Independent Verification Memo: WO-01 Pump Module Selection for the Water-Reclamation Transfer Loop

Verification diagram: recomputed energy ranking on the shared acceptance run with eligibility margins; P2 leads at 12 kWh with verified gaps of 40, 44 and 46 kWh.

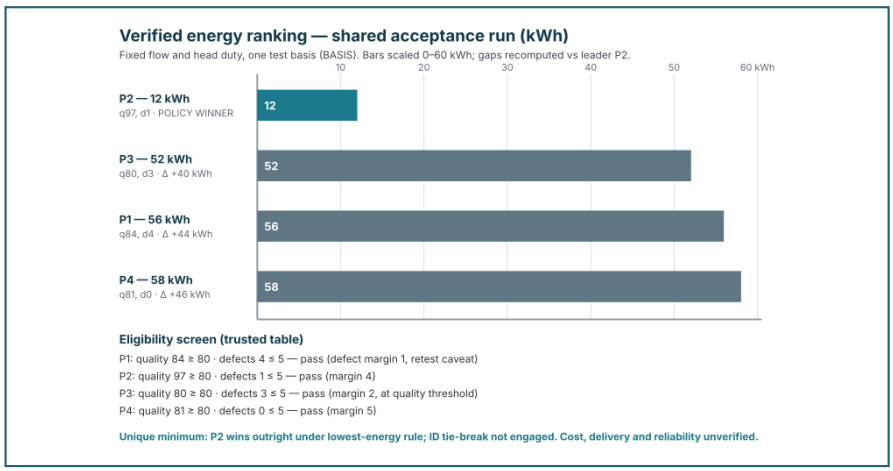
The ranking recomputes as 12, 52, 56 and 58 kWh. My independent gap sums: 52−12=40; 56−12=44; 58−12=46 kWh, matching the analyst's figures. Expressed as multiples of the leader's run, P3 is about 4.33×, P1 about 4.67× and P4 about 4.83×. Because the work order states every module serves the same fixed flow and head on one test basis, these differences reflect module efficiency rather than duty or measurement artifacts — a premise I took from the supplied work order, not from the analyst's report. The minimum is unique at 12 kWh, so the lowest-ID tie-break rule is unnecessary. No cost, delivery or maintenance data exists in the supplied facts, so none enters the ranking.
